# TECHNICAL NOTE

| Project     | Site A Willow Way, Sydenham                  |                           | Project No. | 22/089  |             |
| Subject     | Technical Note in Support of Planning Appeal |                           | Document No | TN004   |             |

**Table 1-1: LBL Officer Report Comments on the Application and VTP Response**

SWEPT PATH ANALYSIS OF LARGE CAR ACCESSING ON-SITE PARKING BAYS

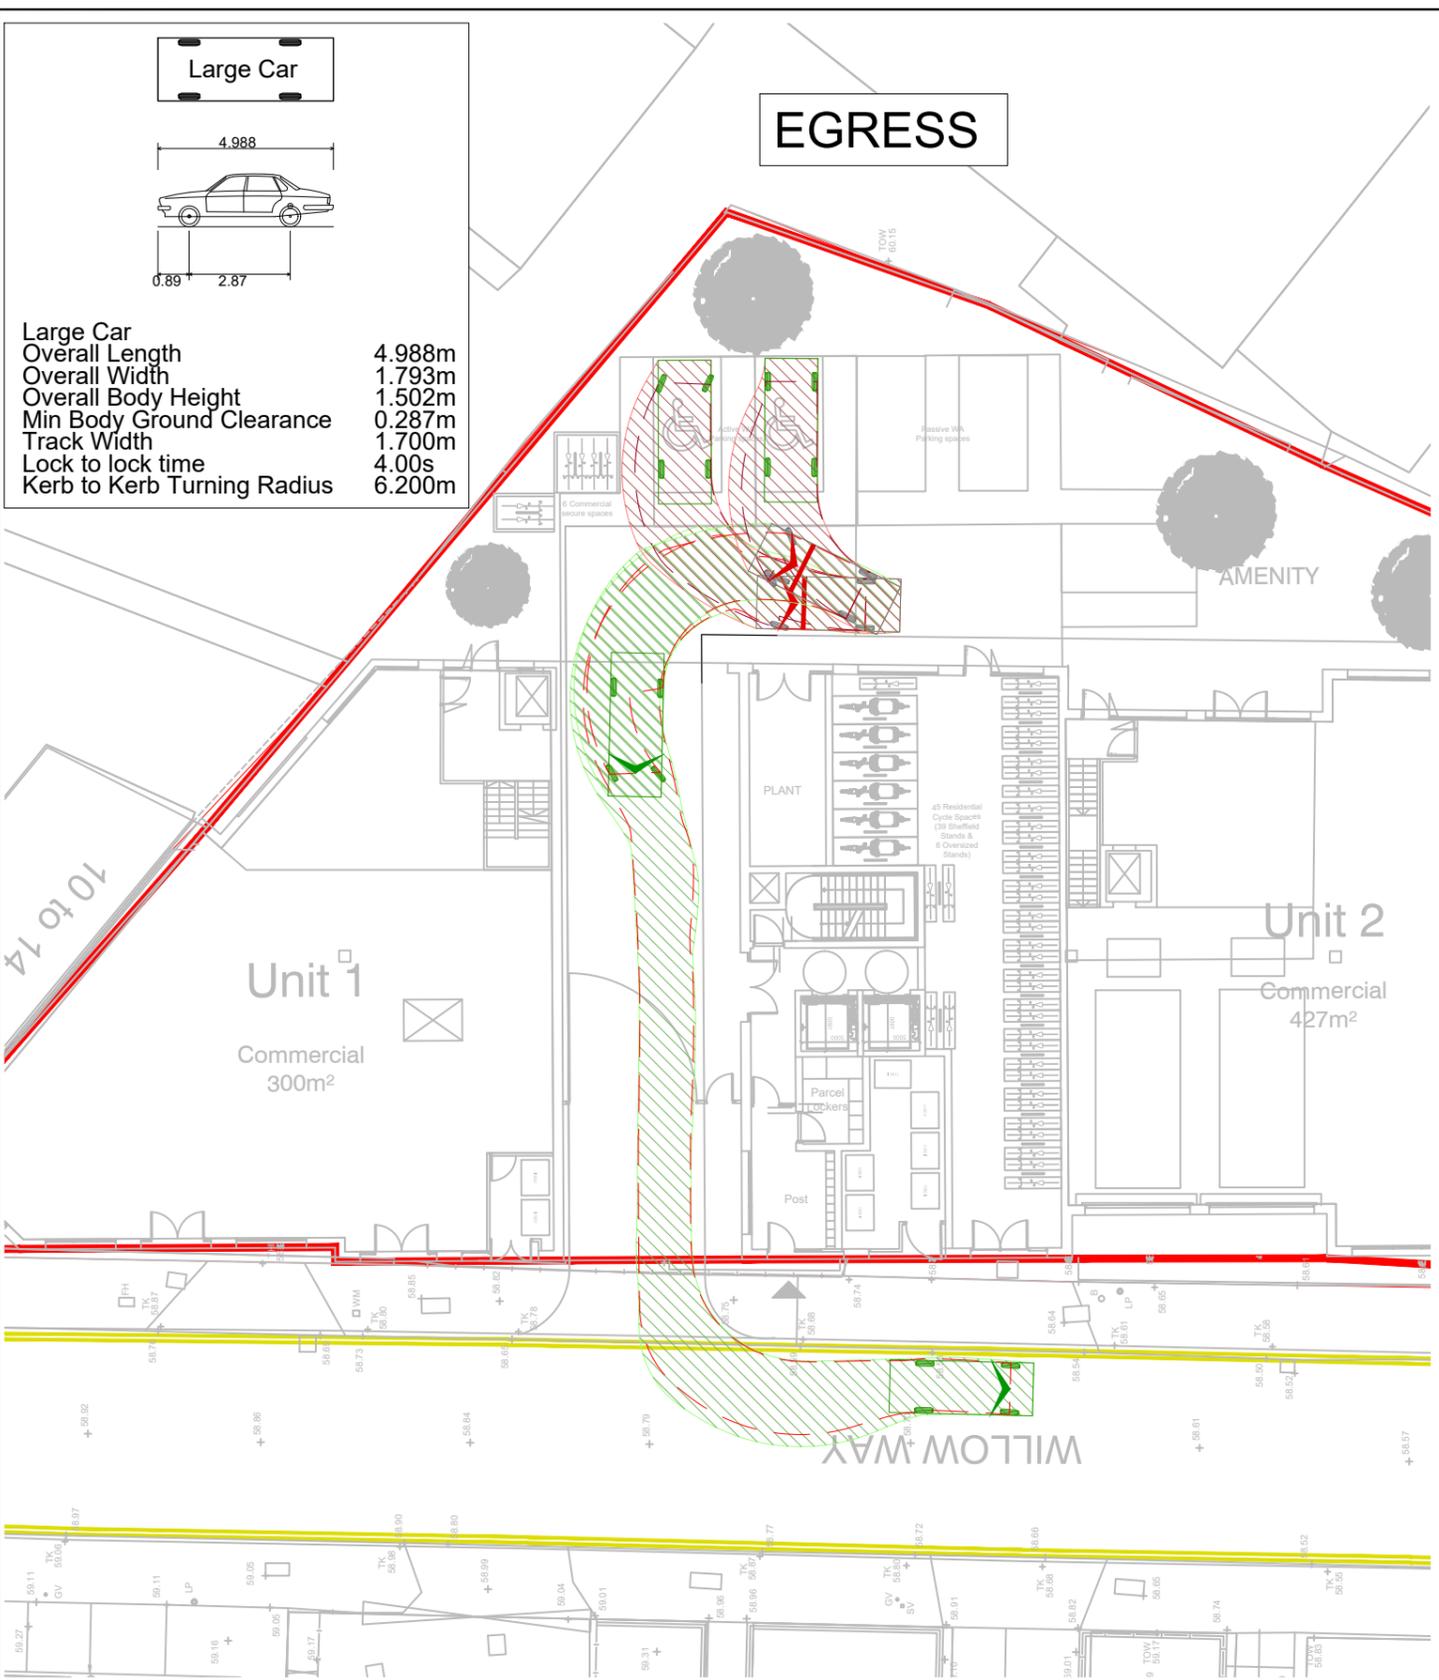
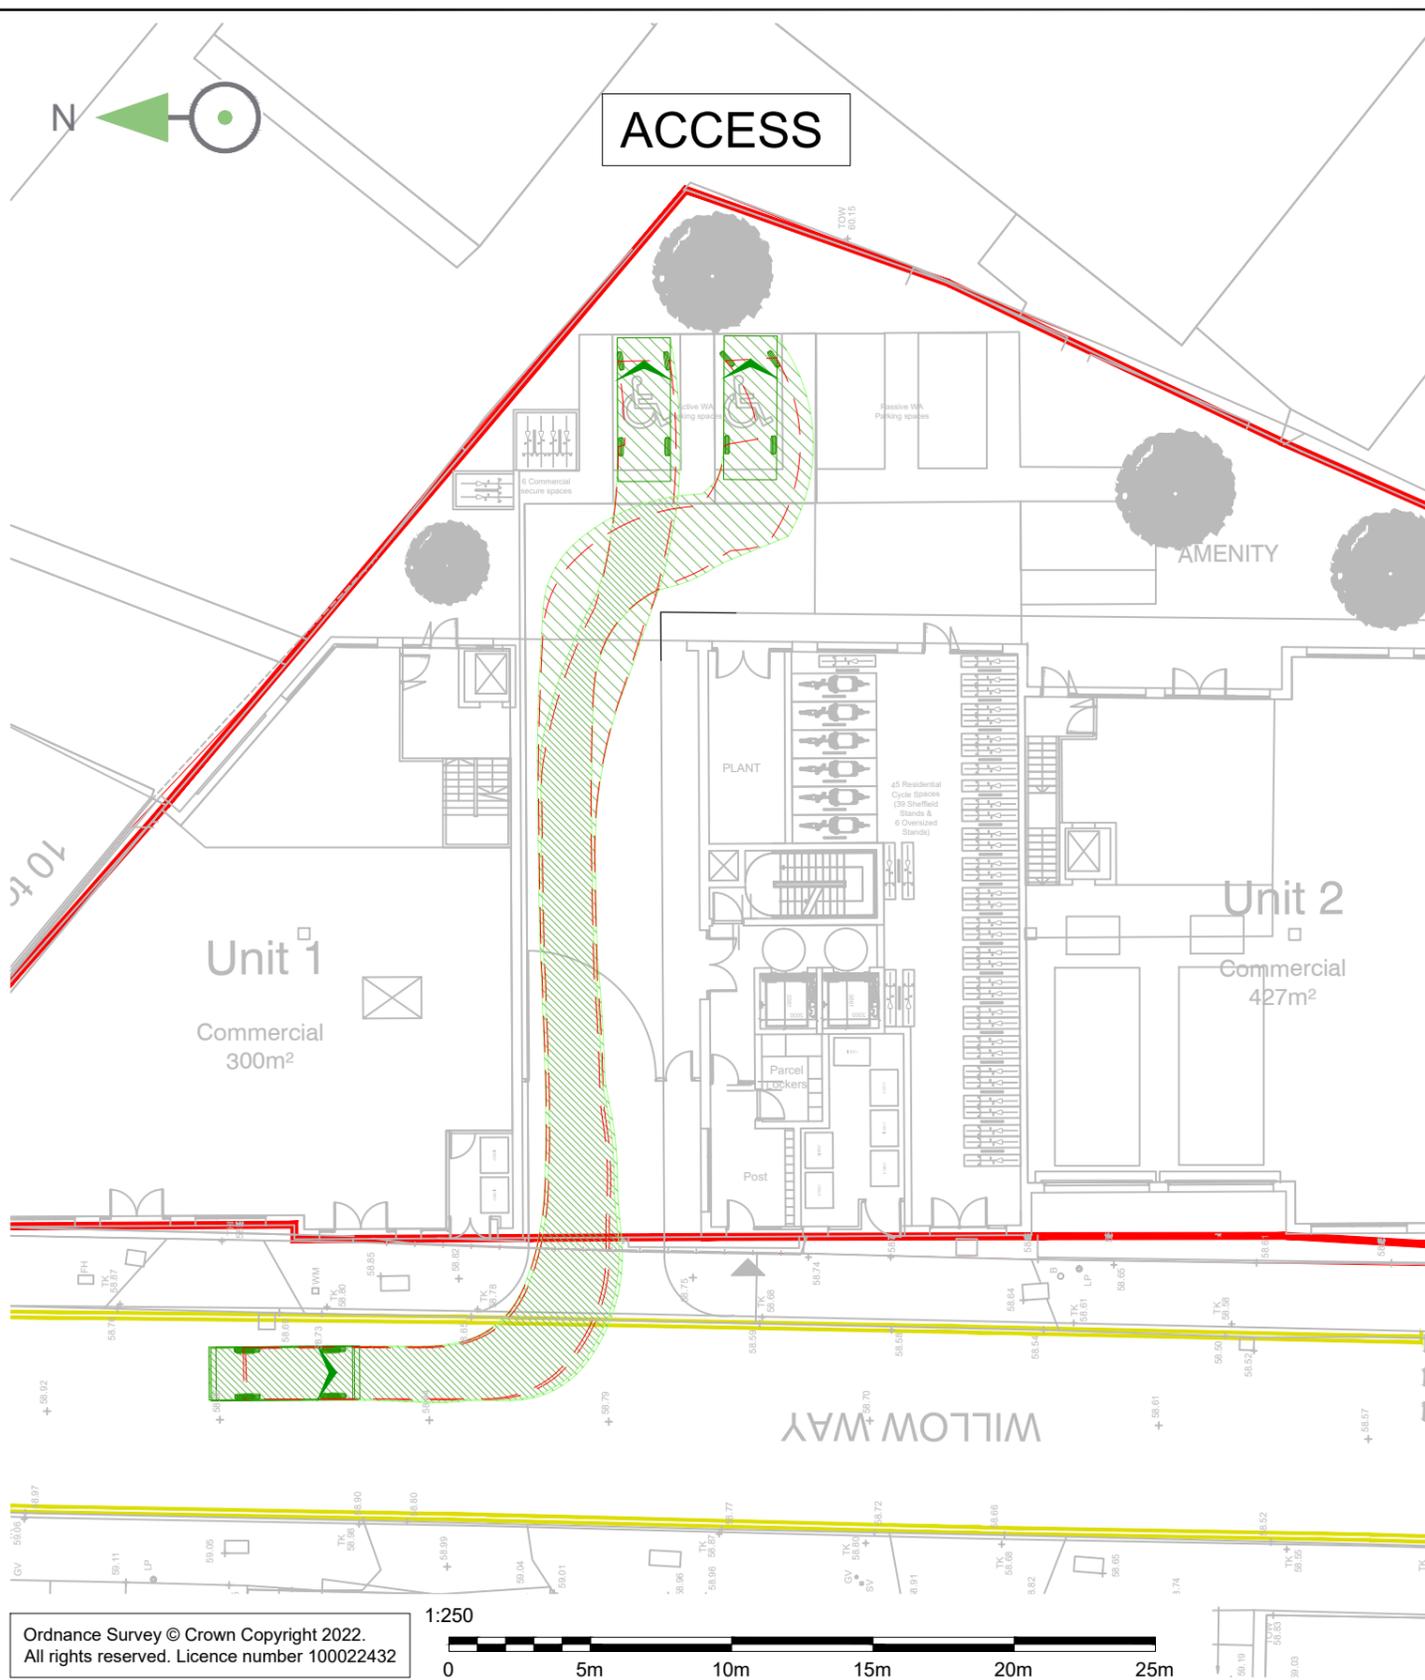
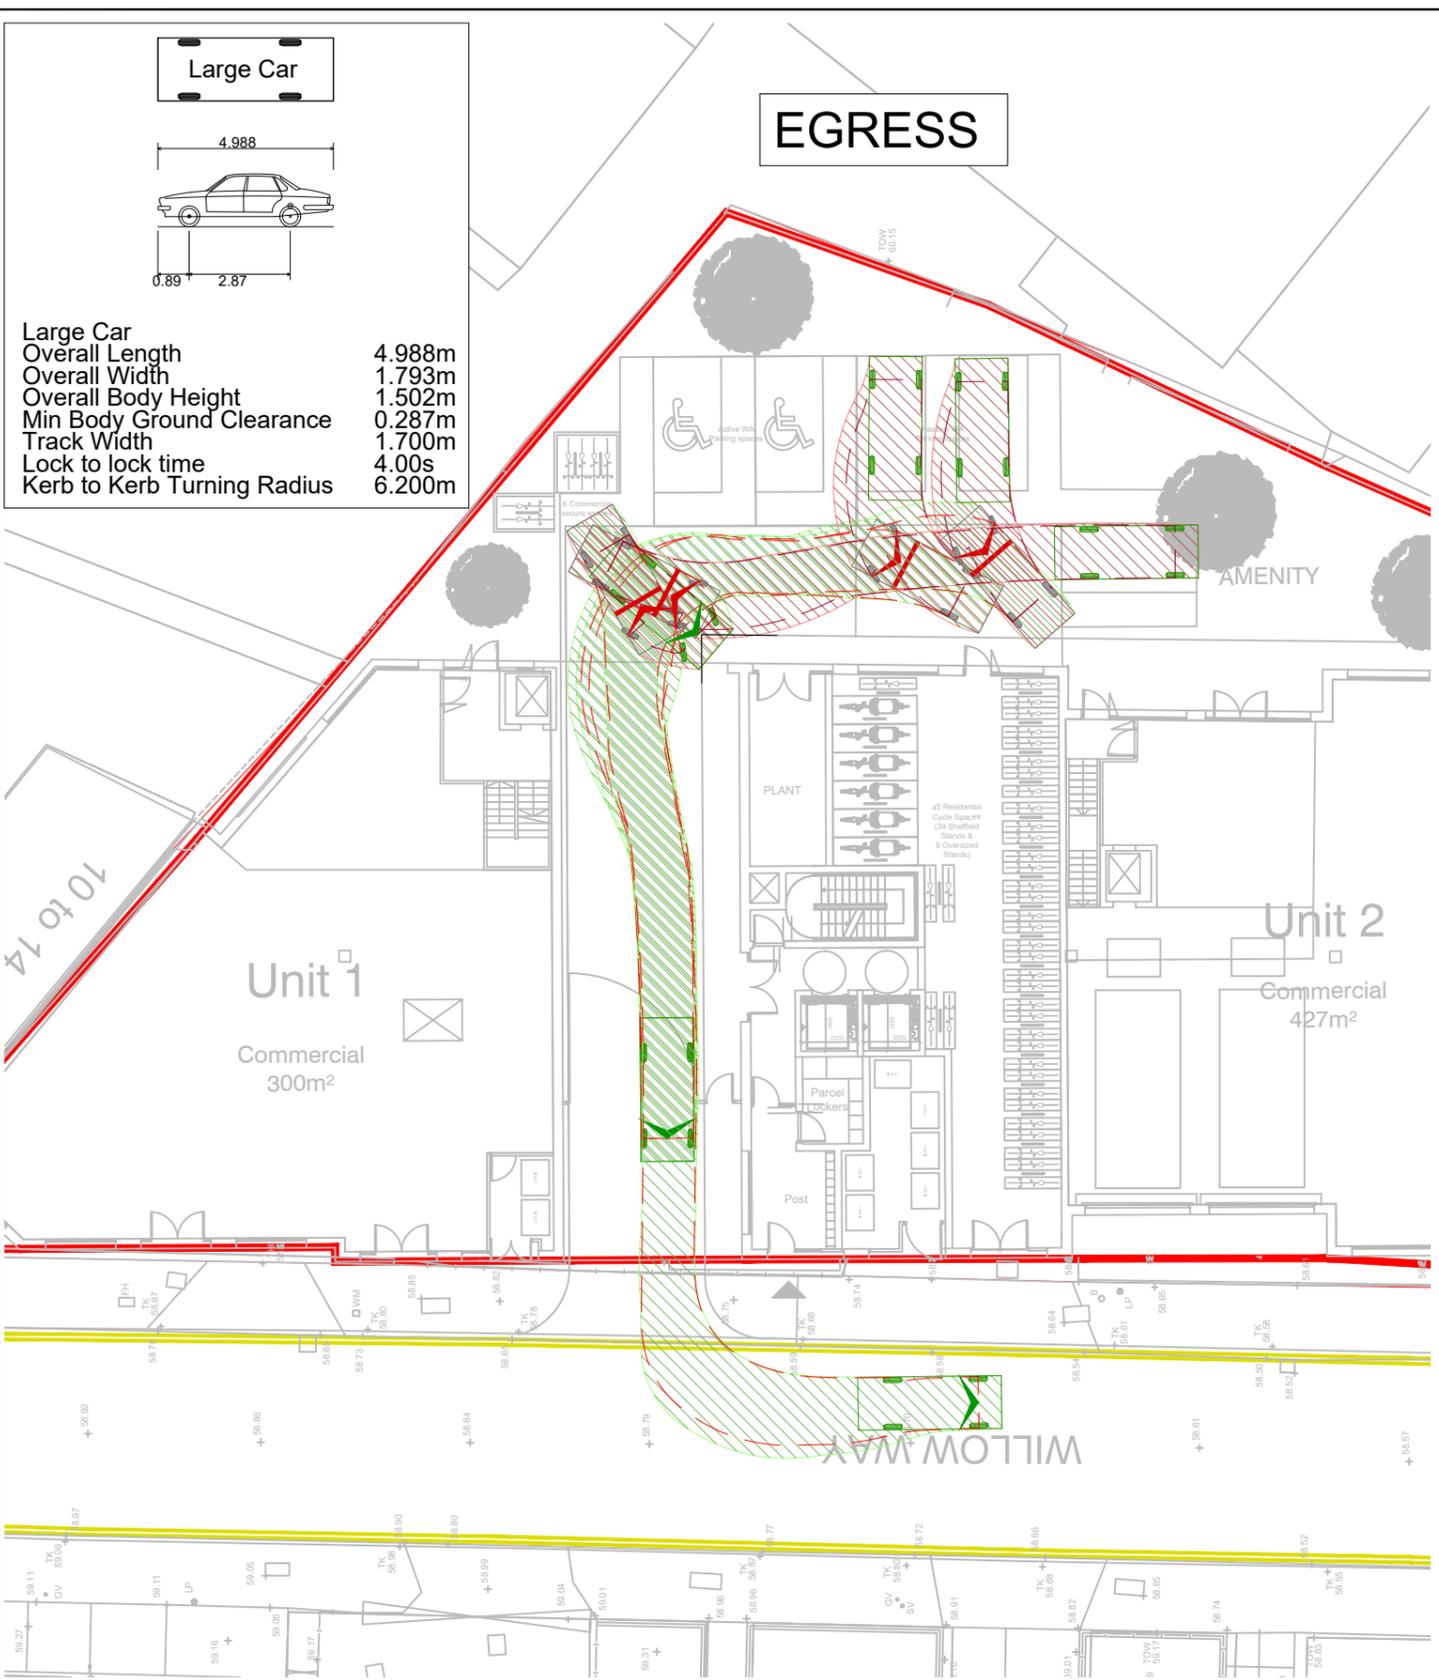
| PARAGRAPH | PLANNING OFFICER / LBL HIGHWAYS COMMENT   | VTP RESPONSE   |
|-----------|---|--|
| 324       | <p><b>Disabled Parking Spaces:</b><br/>The application omits one disabled parking space associated with the commercial proposals for staff or visitors. Policy T6.5 non-residential disabled parking stipulates access to at least one disabled parking bay (on or off street). This will need to be addressed.</p> <p>The application should also be accompanied with swept paths of a large vehicle accessing parking and egressing the site which has not been provided.</p> | <p>It is accepted that a specific disabled parking space for the commercial element has been omitted as part of the application. Given the proposals include safeguarded space on-site to accommodate an extra 3 disabled parking spaces, it is considered that one of these spaces could be allocated to the commercial element in the first instance.</p> <p>An additional on-street space could be provided (within the public highway, and therefore outside of the application boundary) in order to maintain the safeguarded provision for 10% of the residential units to have a disabled parking space. This could be provided as part of the TRO process, should it be required.</p> <p>As the number of blue badge holders within Lewisham's population is around 2% (DfT Statistics, Table DIS0109, 2016 data), it is considered highly unlikely that there will be demand by residents for use of all six disabled bays proposed in the application. Blue badge holders in Lewisham can also park on single or double yellow lines for up to three hours where loading/unloading is permitted (Section 4.3 of LBL Parking Policy, March 2023) meaning any demand by visitors can reasonably be accommodated on-street.</p> |

| PARAGRAPH | PLANNING OFFICER / LBL HIGHWAYS COMMENT   | VTP RESPONSE  |
|-----------|---|---|
|           |   | <p>The revised approach is therefore considered to be acceptable within the constraints of the site.</p> <p>It is anticipated that access to the rear parking court will only be permitted to standard sized service vehicles in exceptional circumstances such as plant needing maintenance. The rear parking court was therefore designed primarily to accommodate movements of cars.</p> <p>Swept path analysis shown in <b>APPENDIX F</b> demonstrates that large cars can access and egress all parking spaces adequately.</p> |
